# **Service Bulletin**

Replacement of wing strut mounting bolts

All GA200 & GA200C aircraft

SB-GA200-2012-08 Issu	Date of Issue: 04.09.201	2 Page <b>1</b> of <b>4</b>
-----------------------	--------------------------	-----------------------------

Strut Fairings

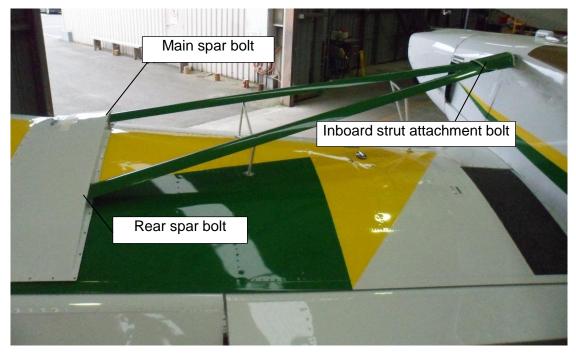
- 1. Remove the main strut/wing fairing assembly and strut/fuselage fairing assembly (if fitted)
- 2. Support the wing as required. Remove and inspect all three strut attachment bolts in turn
- 3. Diameters for each fitting should be as specified below:
  - a. 570006-19 inboard (upper) strut fitting 0.500 to 0.510 inches
  - b. 570006-17 strut fitting main spar 0.375 to 0.385 inches
  - c. 570006-15 strut fitting rear spar 0.750 to 0.760 inches
  - d. 570006-13 eccentric bush rear spar 0.375 to 0.385 inches
- 4. If hole size is correct, proceed to Step 9 otherwise proceed to Step 5

5. If the inboard (upper) strut fitting hole diameter is larger than specified in **step 3**, ream the inboard (upper) strut fitting holes on the strut and the fuselage to a diameter of 0.563 to 0.565 inches

6. If the main spar hole diameter is larger than specified in **step 3**, ream the main spar strut fitting holes on the strut and the wing spar to a diameter of 0.438 to 0.440 inches

- If the hole diameter for the 570006-13 eccentric bush is larger than specified in step
  3, replace the bush with a new 570006-13 bush
- 8. If the rear spar strut hole diameter is larger than specified in **step 3**, notify GippsAero for corrective action

- 9. Re-attach strut to wing in accordance with the Service Manual, section 57-10-10. The following hardware is to be used in lieu of the original fit:

- a. Replace AN8-23A bolt with NAS6608-29 bolt, or
  - b. Replace AN8-23A bolt with NAS6609-29 bolt if hole has been reamed oversize
  - c. Replace AN6-23A bolt with NAS6606-31 bolt, or

- d. Replace AN6-23A bolt with NAS6607-31 bolt if hole has been reamed oversize
  - e. Replace AN6-15A bolt with NAS6606-21 bolt
  - f. Use AN365-820 nut and MS27151-24 Pal Nut

- g. Use AN365-918 nut and MS27151-25 Pal Nut
  - h. Use MS21042-6 nut and MS27151-19 Pal Nut
  - i. Use AN365-720 nut and MS27151-21 Pal Nut
  - j. Use AN960- washers as required
